## FORD E4OD "UPDATE HANDBOOK"

### INDEX

Figure 1

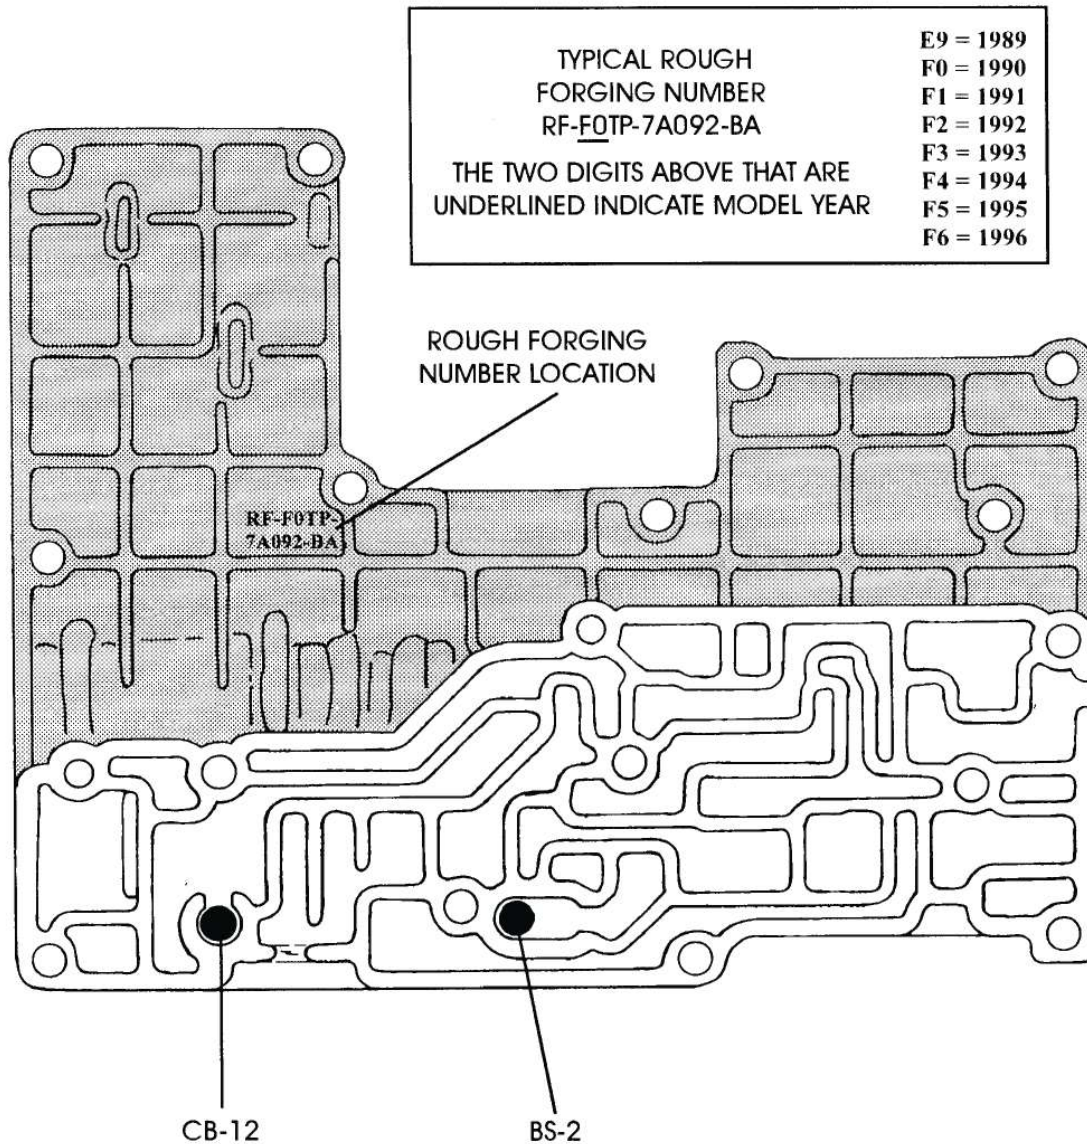
- (1) **VALVE BODY CHECKBALL LOCATIONS** - Have remained the same for 1989 thru 1995 model years, with **TWO** 5/16" rubber checkballs, and their locations are shown in Figure 1. Beginning in the 1996 model year there are **FIVE** checkballs in the main valve body and their locations are shown in Figure 2. Notice that there are two 5/16" rubber balls and three 1/4" rubber balls. The 1/4" rubber balls are green in color (See Figure 2).

Figure 3  
AUTOMATIC TRANSMISSION SERVICE GROUP  
8

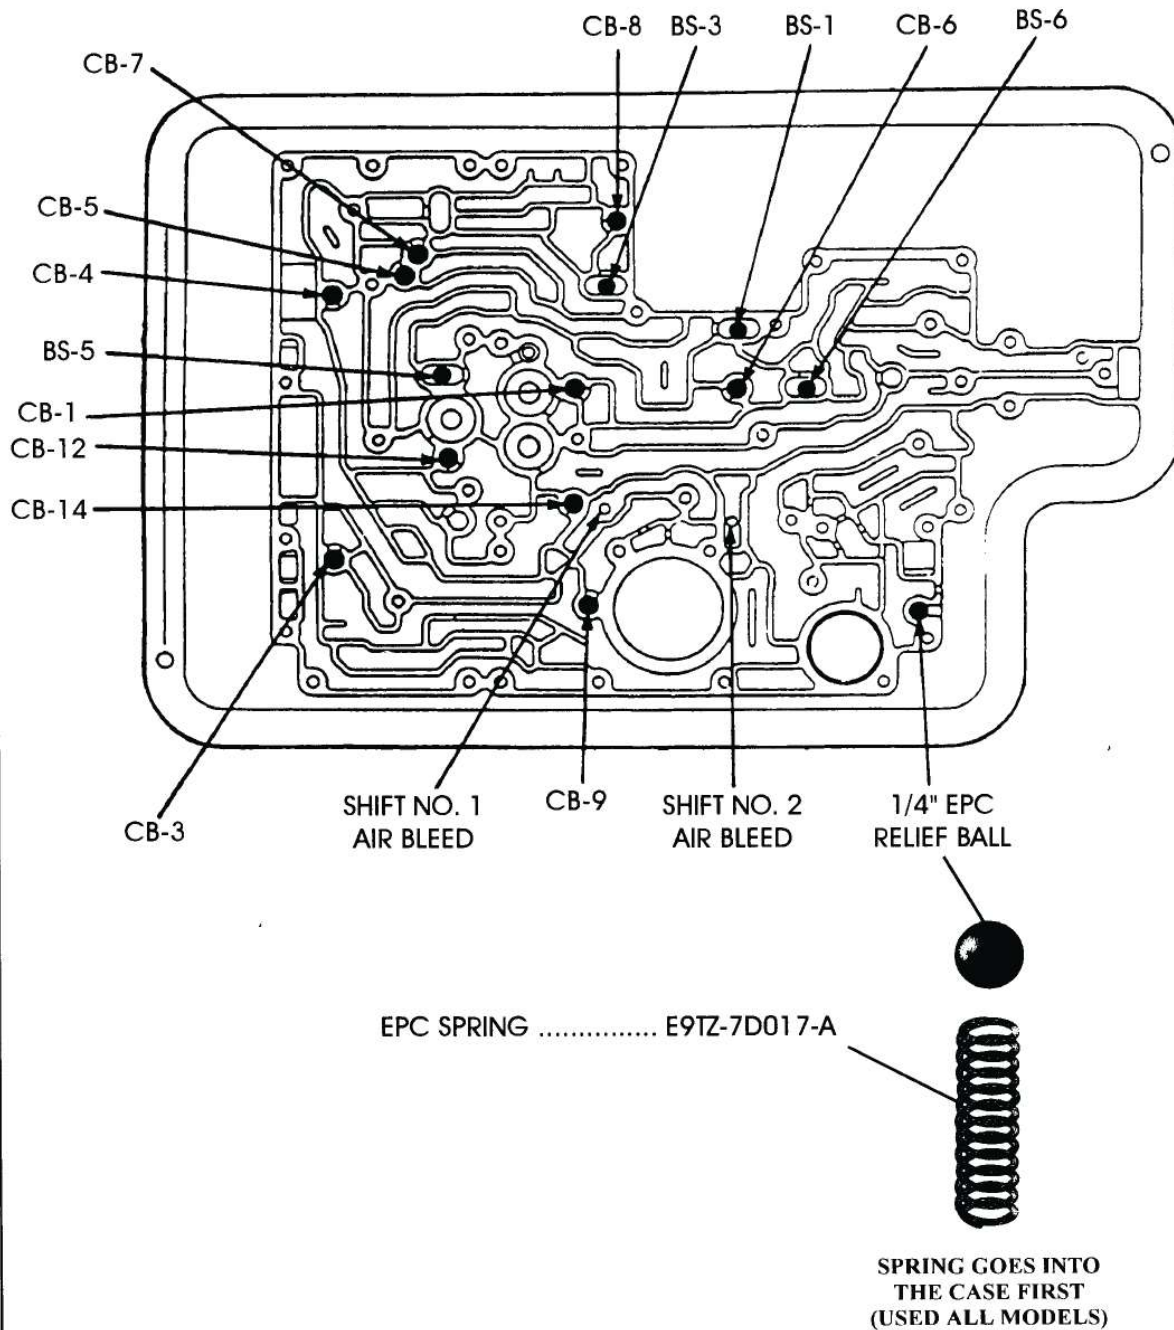
- (2) **CASE CHECKBALL LOCATIONS** - Have now changed **three times** since the introduction in 1989, as listed below.
  - Early 1989 Models** - Requires **Fourteen** 5/16" checkballs in the case, in the locations shown in Figure 3, and uses a 1/4" steel ball for the EPC blow-off, and location shown in Figure 3.

Figure 4

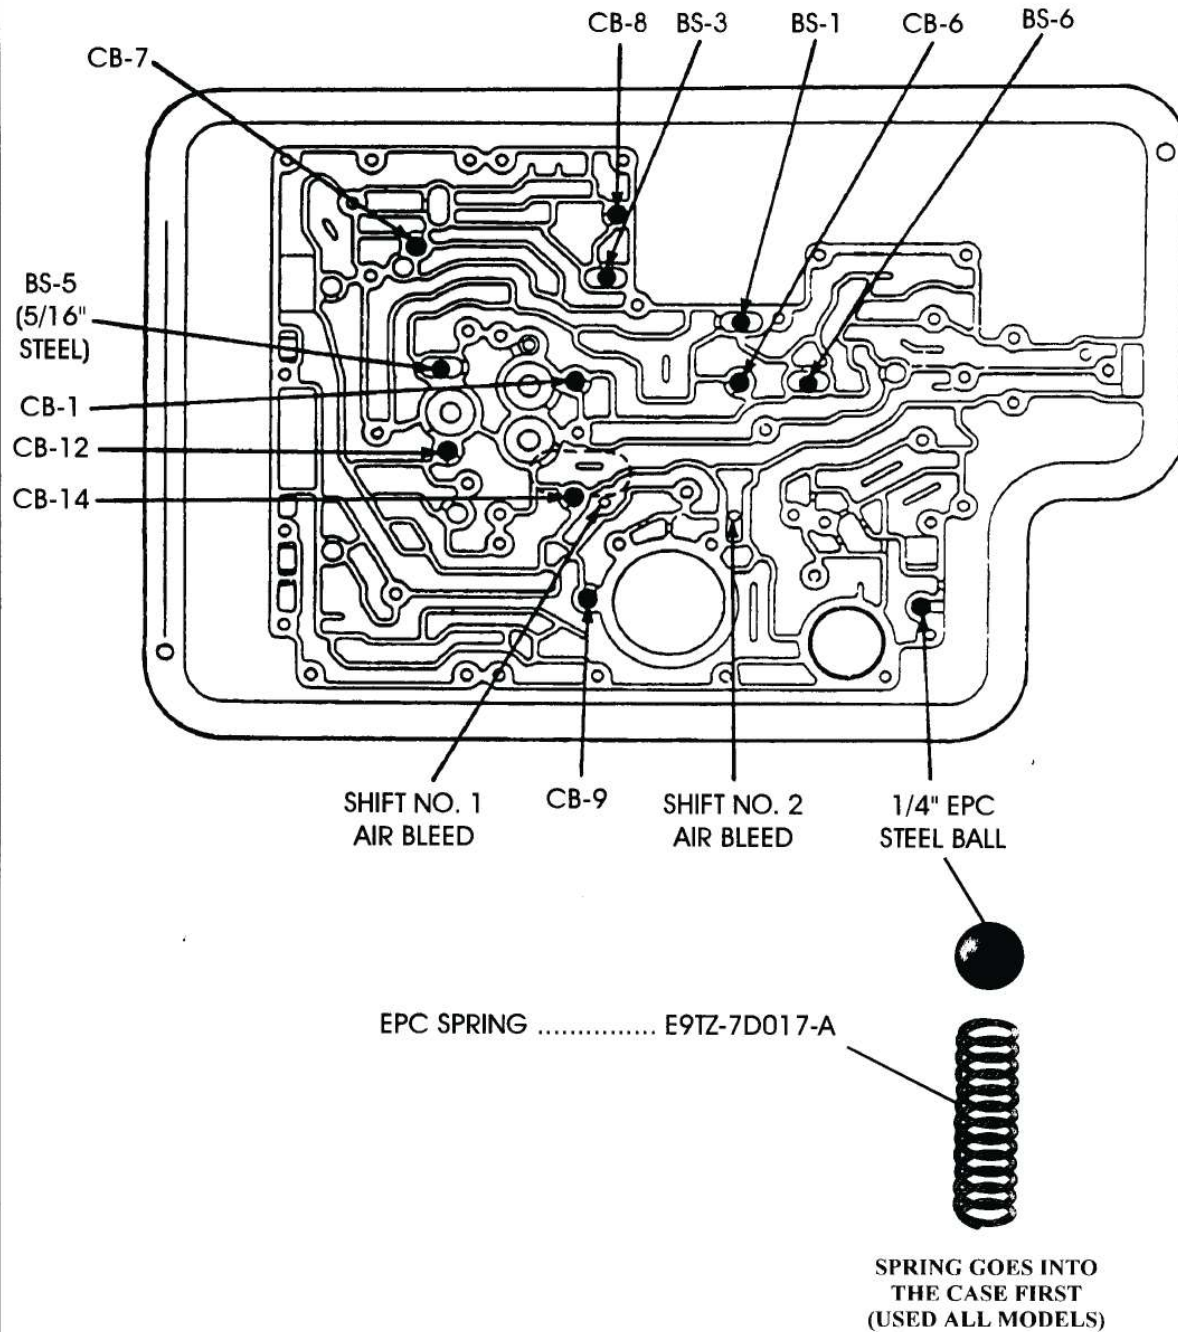
- Late 1989 Models** - Requires **Ten** 5/16" rubber checkballs, and **One** 5/16" diameter steel checkball, for a total of **Eleven**, in the locations shown in Figure 4, and uses a 1/4" steel ball for the EPC blow-off, and the location is shown in Figure 4.

Figure 5

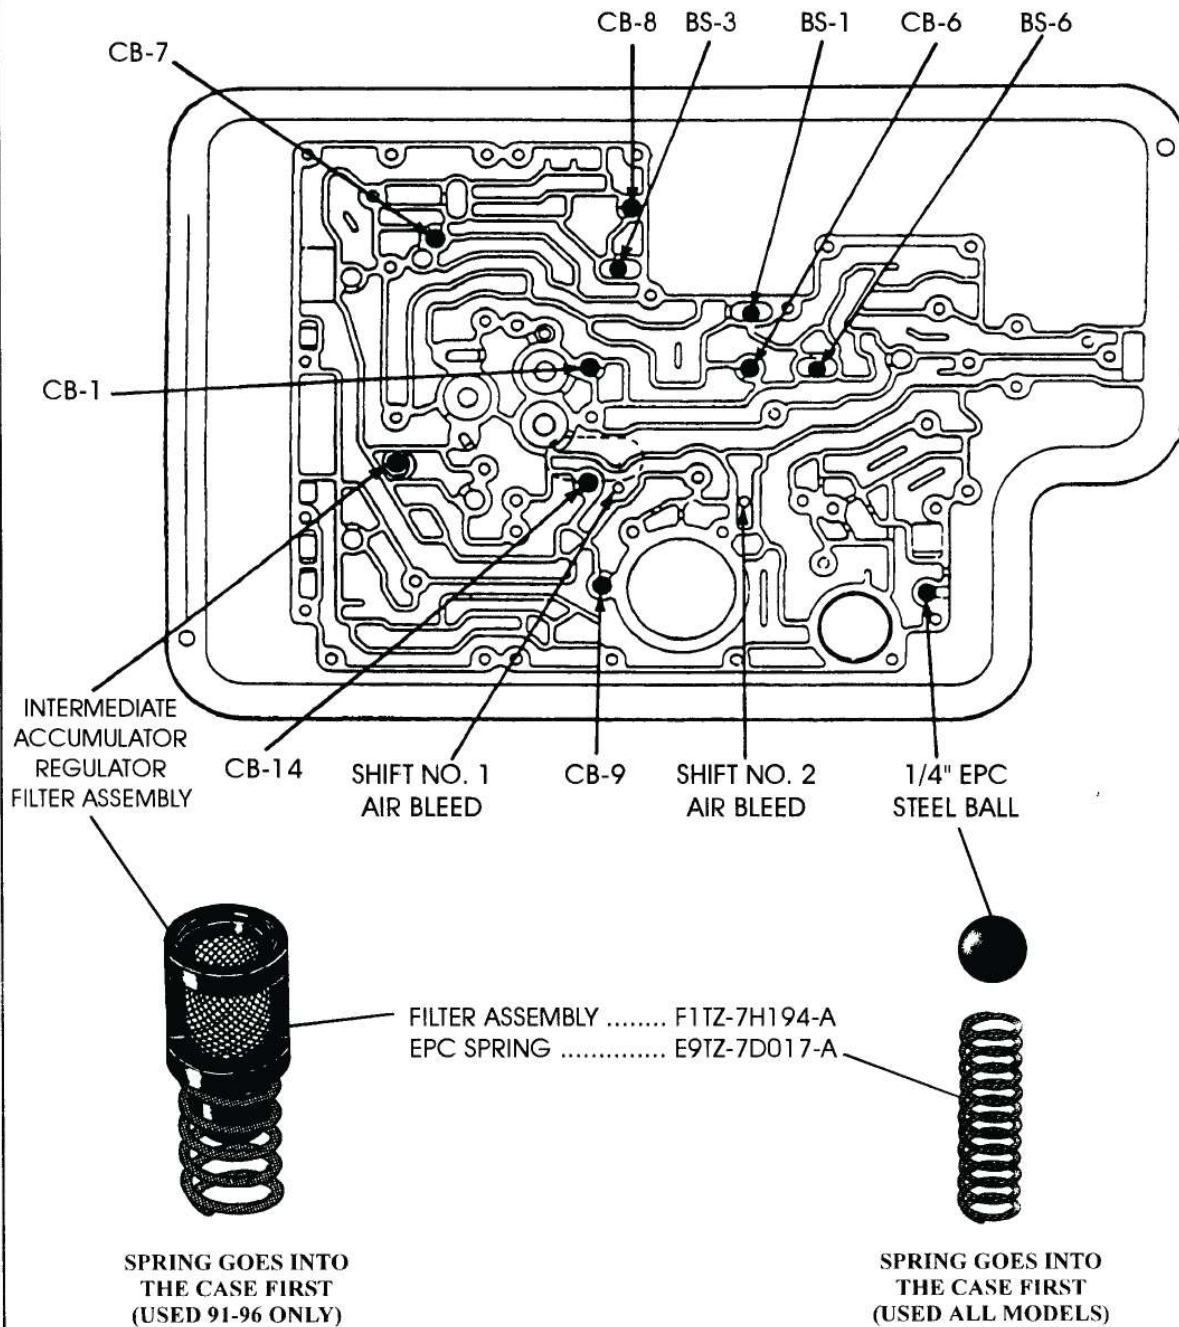
- All 1990-1995 Models** - Requires **Nine** 5/16" rubber checkballs in the case, in the locations shown in Figure 5, and uses a 1/4" steel ball for the EPC blow-off, and the location is shown in Figure 5. Beginning in 1991 there is an added Intermediate Accumulator Regulator Filter Assembly, and the location in the case is shown in Figure 5.

Figure 6  
AUTOMATIC TRANSMISSION SERVICE GROUP

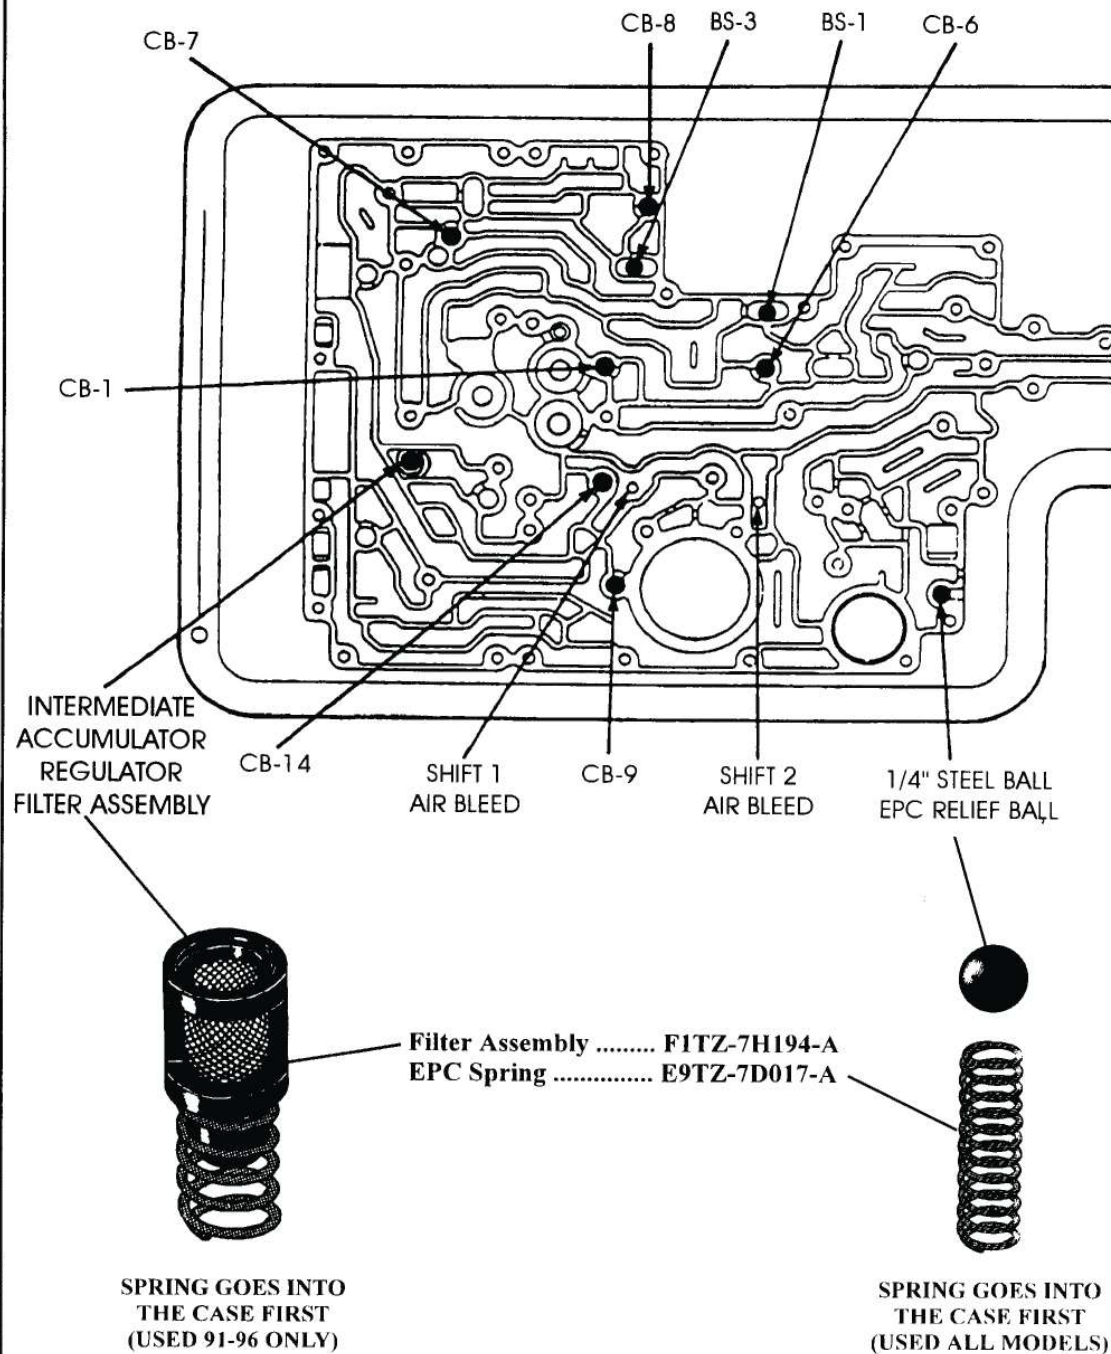
- All 1996-UP Models** - Requires **Eight** 5/16" rubber checkballs in the case, in the locations shown in Figure 6, and uses a 1/4" steel ball for the EPC blow-off, and the location is shown in Figure 6.

Figure 9

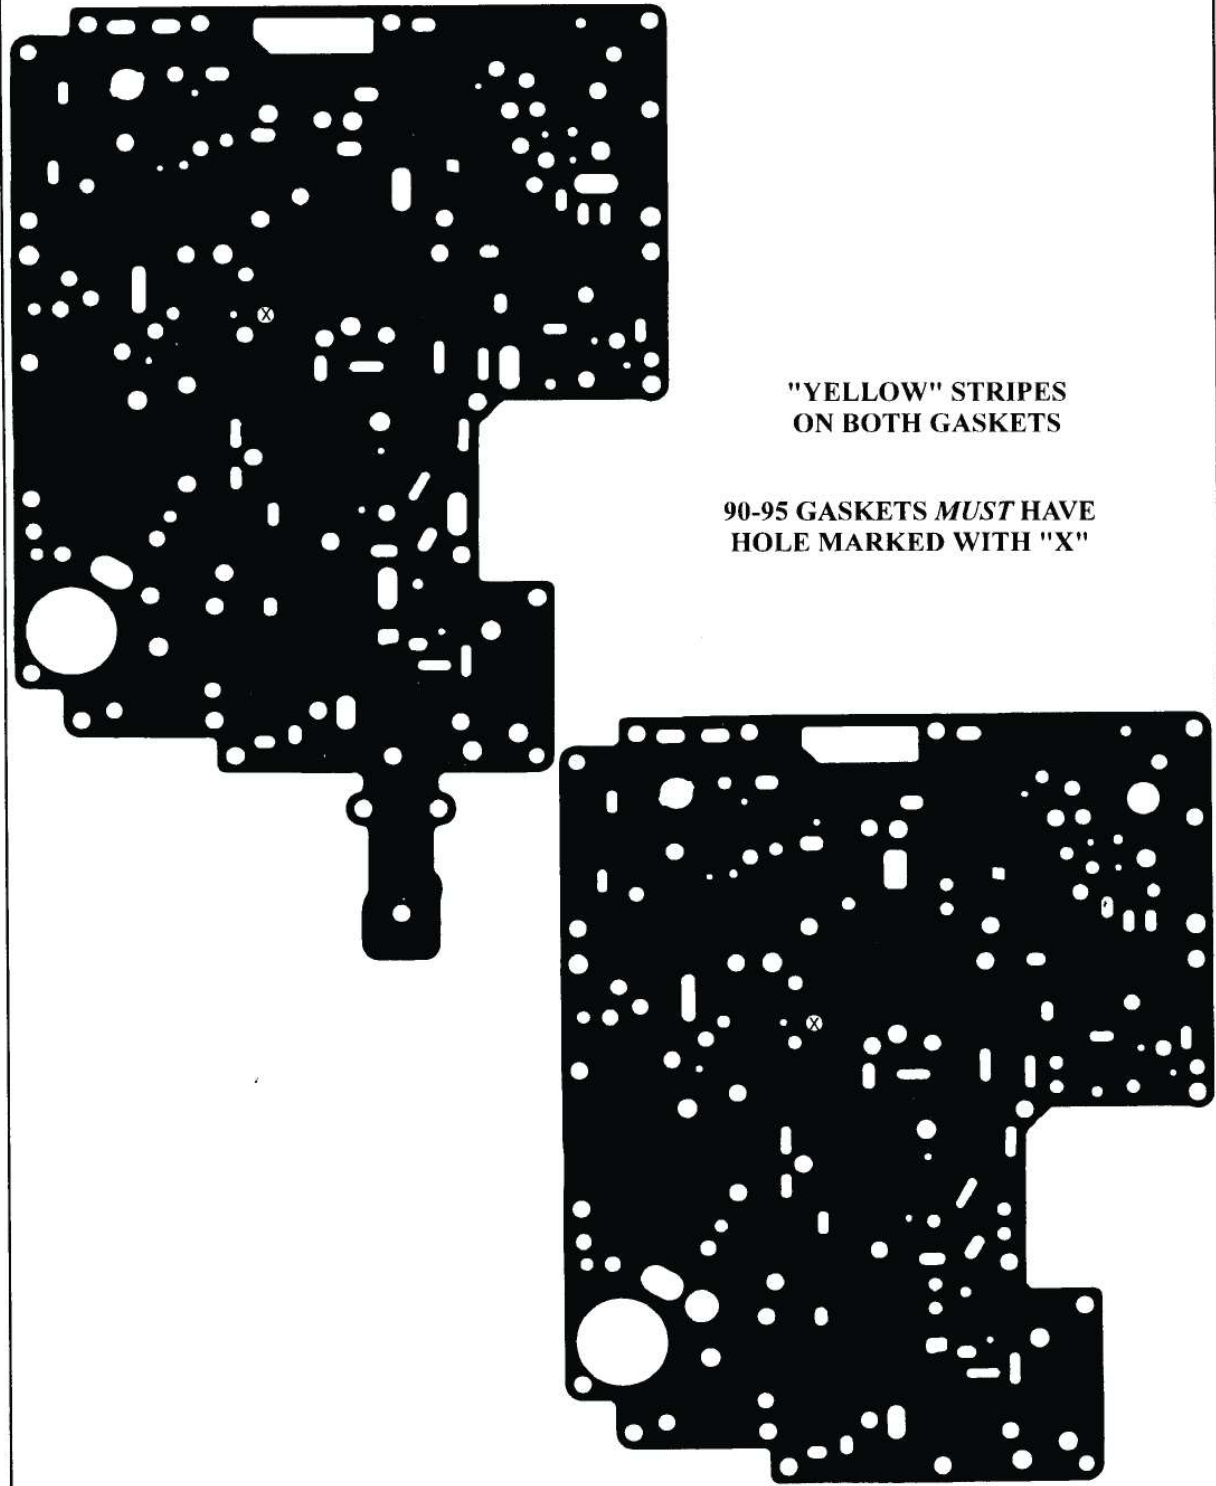
- 90-95 Models Only** - Require the Spacer Plate Gaskets with solenoid feed hole (Marked X) in the location shown in Figure 9, and both gaskets have **Yellow I.D.** stripes

Figure 10

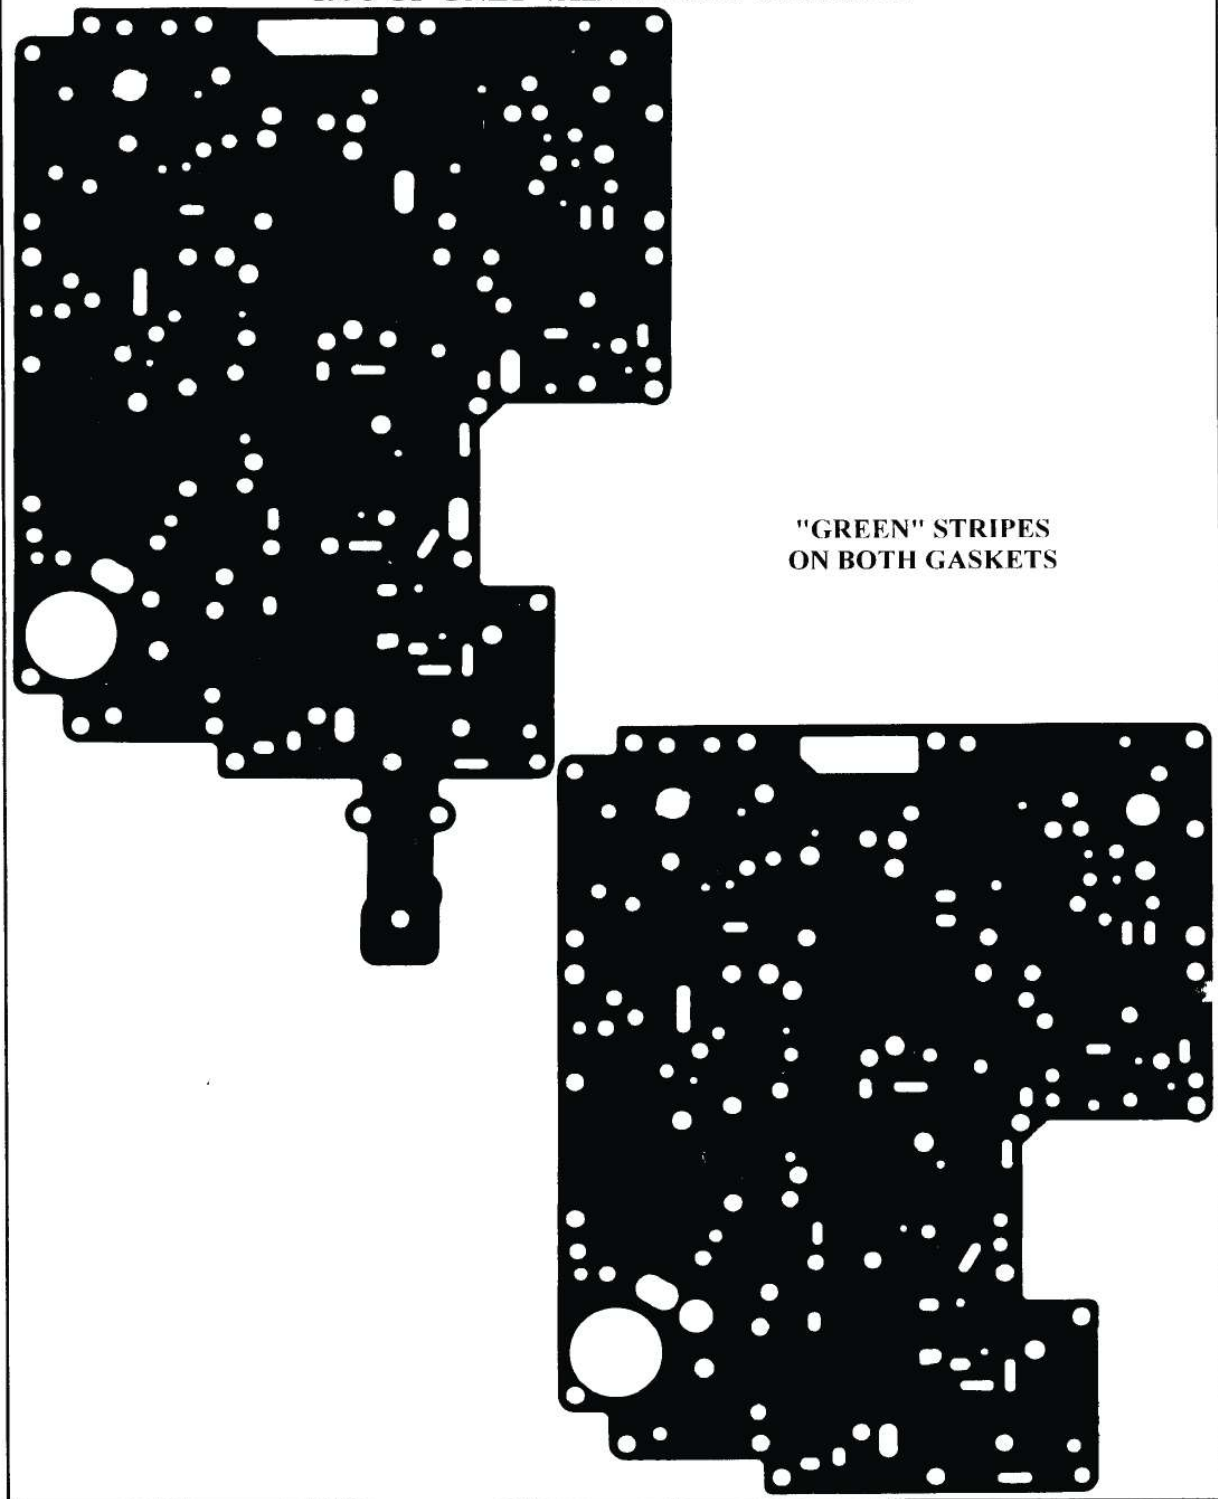
- 96-UP Models Only** - Require the Spacer Plate Gaskets with **Green I.D.** stripes on both gaskets. These gaskets have a multitude of hole location differences, as shown in Figure 10.
